# Product Change Notification

May, 2018

## Bourns® Model PQ2614BHA, PQ2614BLA and PQ2617BHA Series Shielded Power Inductors

### Change to Mounting Platform Design and use of Epoxy

Part Number	Platform	
	Current	New
<a href="#">PQ2614BHA Series</a> <a href="#">PQ2614BLA Series</a> <a href="#">PQ2617BHA Series</a>

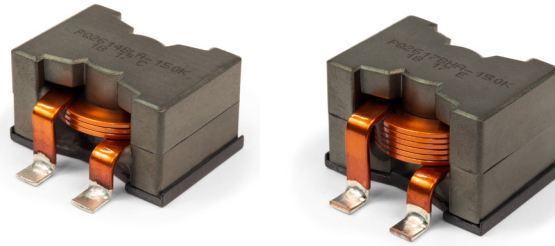
Effective immediately, Bourns is changing the mounting plate design to include a protruded edge to the left, right and back side of the platform and also grids to the surface. These changes will help enhance the inductor's ability to withstand mechanical shock, vibration and increase adhesion strength between the platform and the inductor's core. The use of an adhesive material throughout the inductor assembly is also changing from a 2-part epoxy to a 1-part epoxy for a simplified manufacturing process.

The change to the mounting platform design will affect the inductors' form. The fit and function remain unchanged. The quality and reliability of the inductors should be improved. The change to the use of epoxy will not affect the inductors' form, fit, function, quality or reliability. Affected part numbers are shown on page 2.

First date code using the above changes: **1816**
